Impedance balance requirements for 2.5G & 5GBASE-T link segments

Theo Brillhart – Fluke Electronics

Recent Fluke Comment (Atlanta)

MDI Impedance Balance proposals

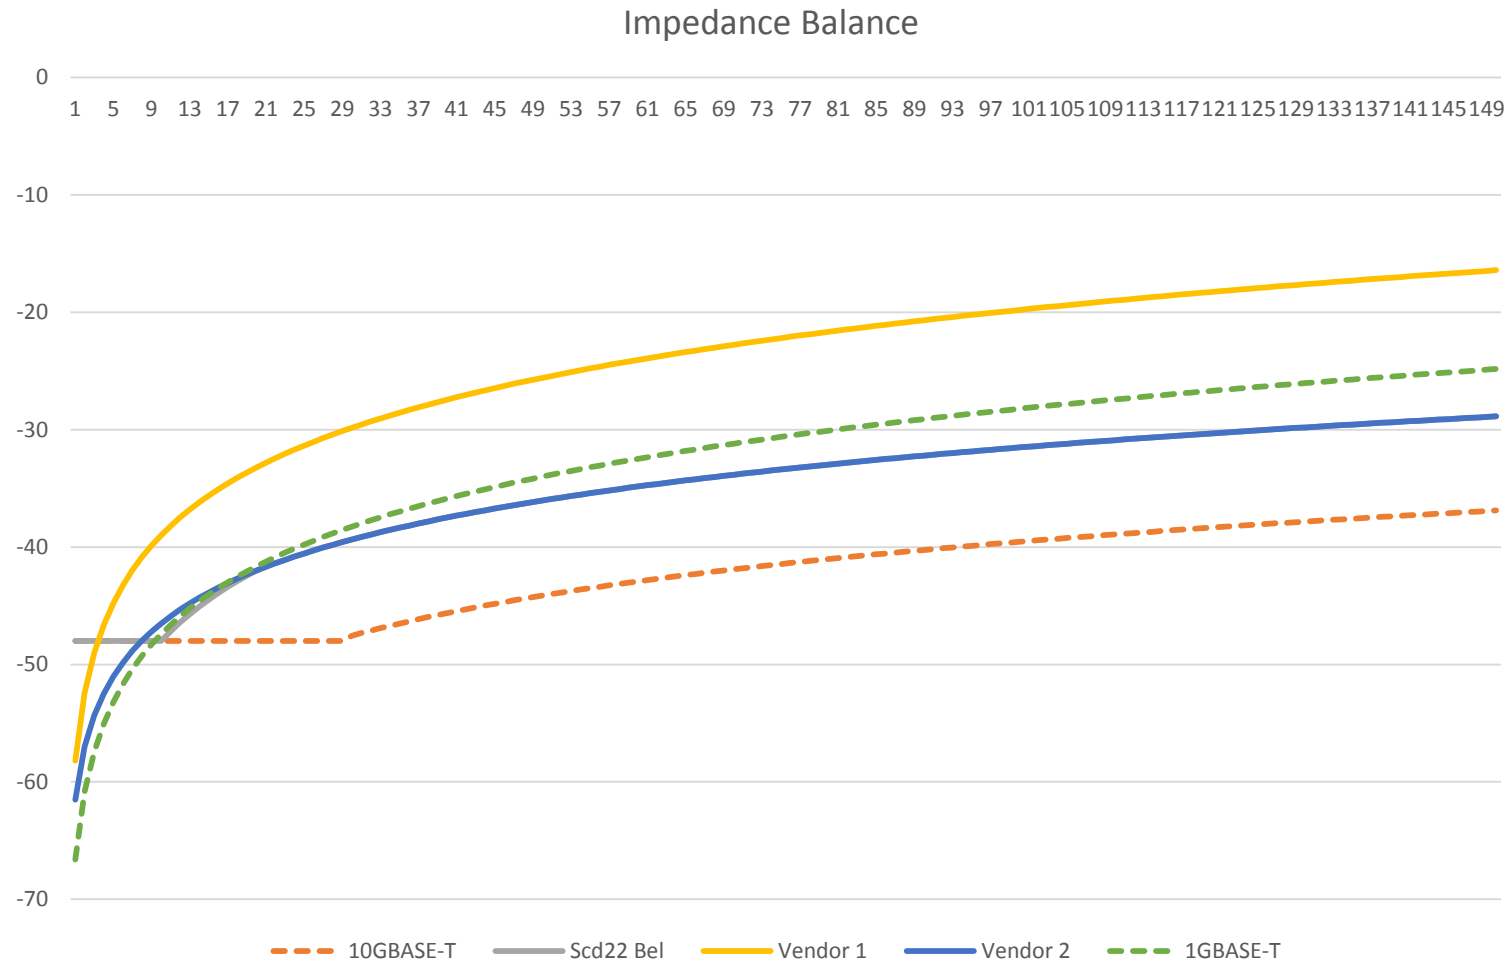
- MDI has explicit impedance balance requirements (clause 126.8)
 - Historically these are derived to provide margin against the CM output voltage being sufficient to exceed the Class A emission limits (see Cobb_0705).
- The CMRR test has *implied* minimum mode conversion requirements for the media used in the test setup (Annex 113A)
 - The +6 dBm input voltage is similarly derived from immunity test limits (see Cobb_0505).
- Poorly balanced cabling can contribute to failing EMC tests.
- Prudent system design would seem to dictate that these minimums be compared to the link segment requirements.

Compare Class D channel TCL

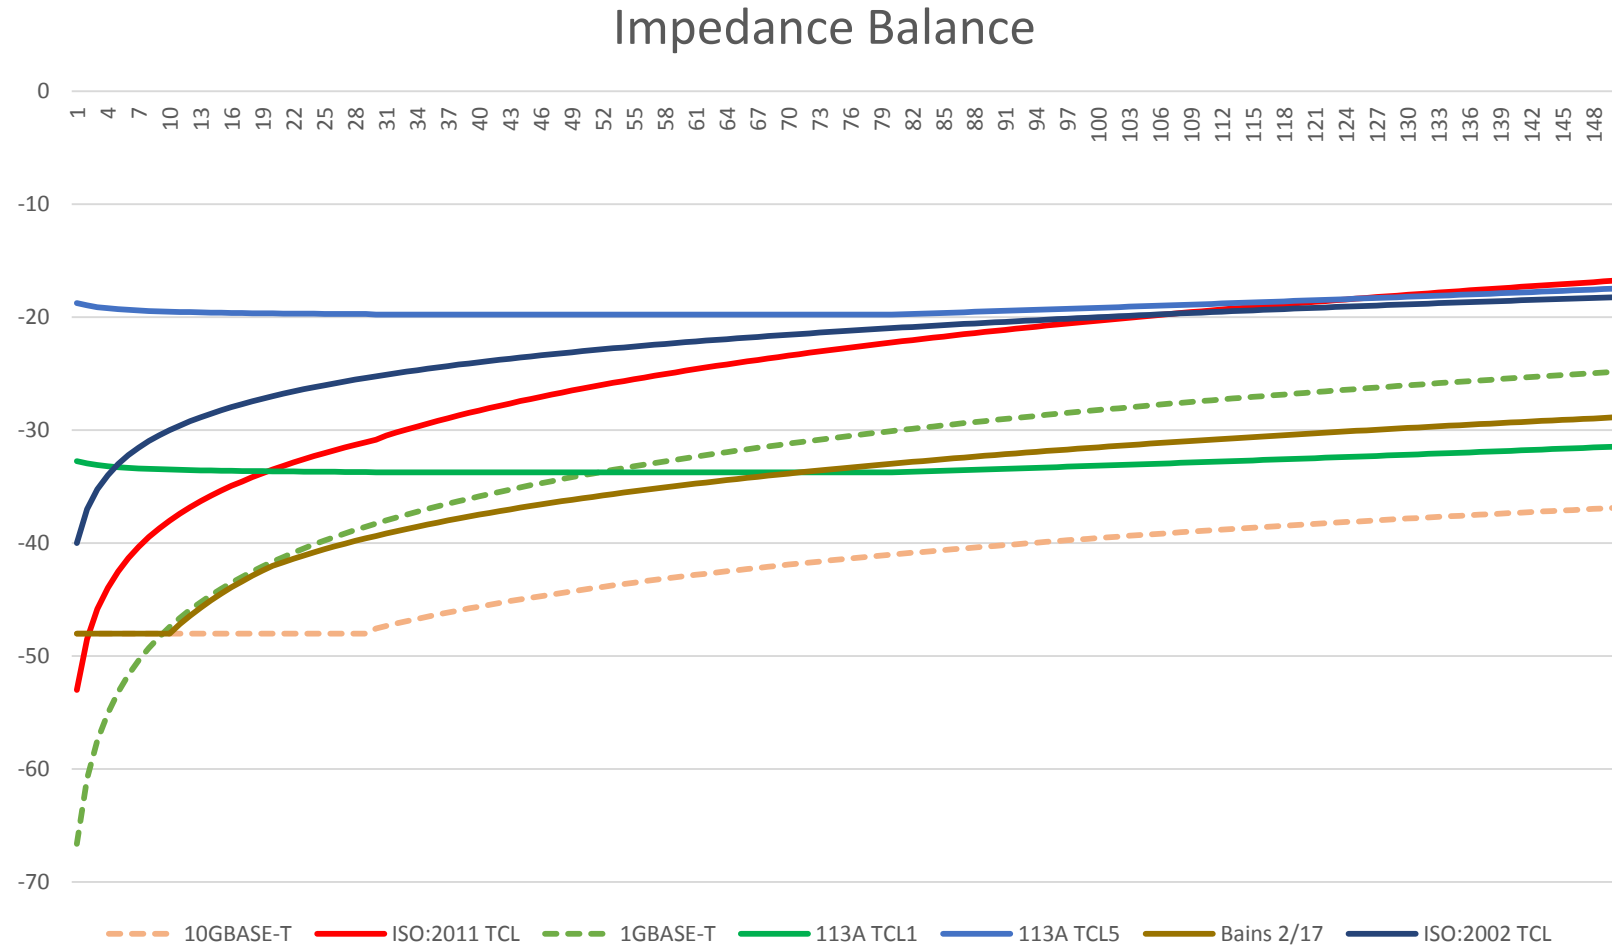
- Prudent system design would seem to dictate that impedance balance minimums be compared to the link segment requirements for TCL, in order to assure reliable operation of the PHY at speed. (We just did that.)
- I have no desire to throw out, or even challenge, the ISO limits. They are what they are.
- Personal experience: poorly balanced cabling will not hold a 1Gb/s link, let alone 2.5G or 5G transmission.
- Based on these comparisons, we have enough reason to at least make the ISO limits as an explicate minimum for 802.3bz, listed in clause 126.7.
